UNITED STATES PATENT AND TRADEMARK OFFICE

APPLICATION NO.	FILING DATE	FIRST NAMED INVENTOR	ATTORNEY DOCKET NO.	CONFIRMATION NO.
09/851,576	05/10/2001	Yao-Ching Su	ADTP0033USA	3197

Office Action Summary

DETAILED ACTION

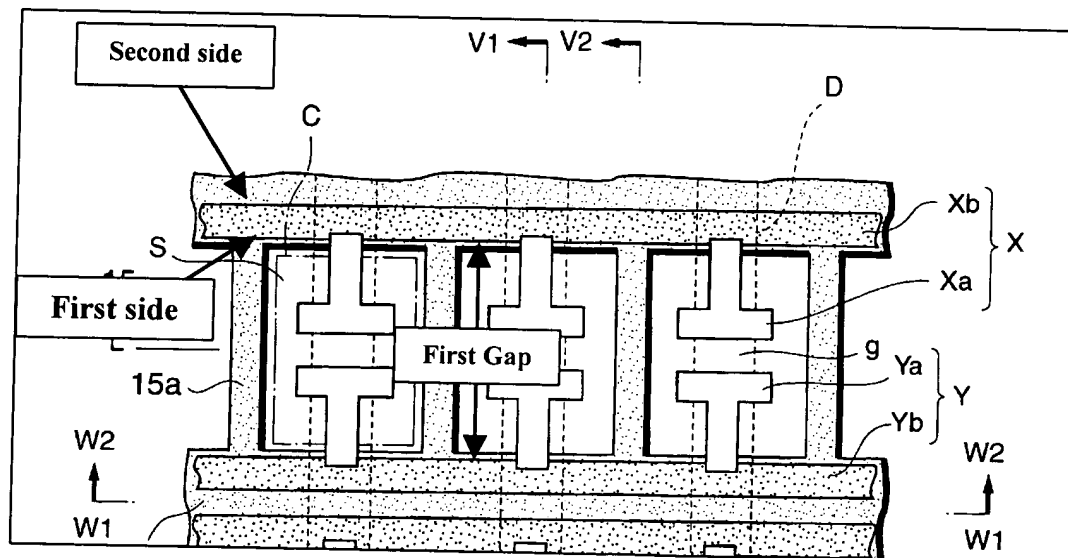
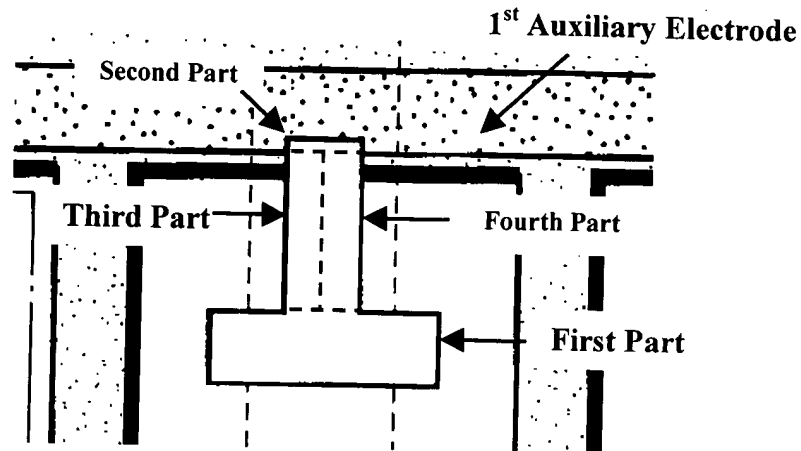
In regard to claim 1, Koshio teaches in figures 1 and 2, an electrode structure of a plasma display panel with a first sustaining electrode (Xb) and a second sustaining electrode (Yb) set on the surface of the front substrate (10), and a first gap (shown below) existing between the first and second sustaining electrodes, the first sustaining electrode having a first side (shown below) approaching to the second sustaining electrode and a second side (shown below) far from the second sustaining electrode; and a first auxiliary electrode (Xa) electrically connected to the first sustaining electrode, the first auxiliary electrode comprising a first part (shown below) and a second part (shown below), the first part formed in the first gap (shown below) and the second part located above the first sustaining electrode; wherein a second gap (g) exists between the first part of the first auxiliary electrode and the second sustaining electrode, and the width of the second gap is smaller than the width of the first gap.

Koshio does not specifically disclose the second part of the auxiliary electrode is adjacent to the first side of the first sustaining electrode.

However, it would have been obvious to one having ordinary skill in the art at the time the invention was made to construct the second part of the auxiliary electrode adjacent to the first side of the first sustaining electrode, since it is well known in the art that modifying the edge of the auxiliary electrode to be adjacent to the first side of the first sustaining electrode is a design choice, and one of ordinary skill in the art will recognize that making the auxiliary electrode adjacent to the first side of the sustaining electrode will save on material, and will lower the overall cost of manufacturing.

In regard to claim 2, Koshio teaches all of the recited limitations of claim 1 (above). Koshio further teaches in figure 1 that the first auxiliary electrode further comprises a third part (shown above) approaching to the second side of the first sustaining electrode.
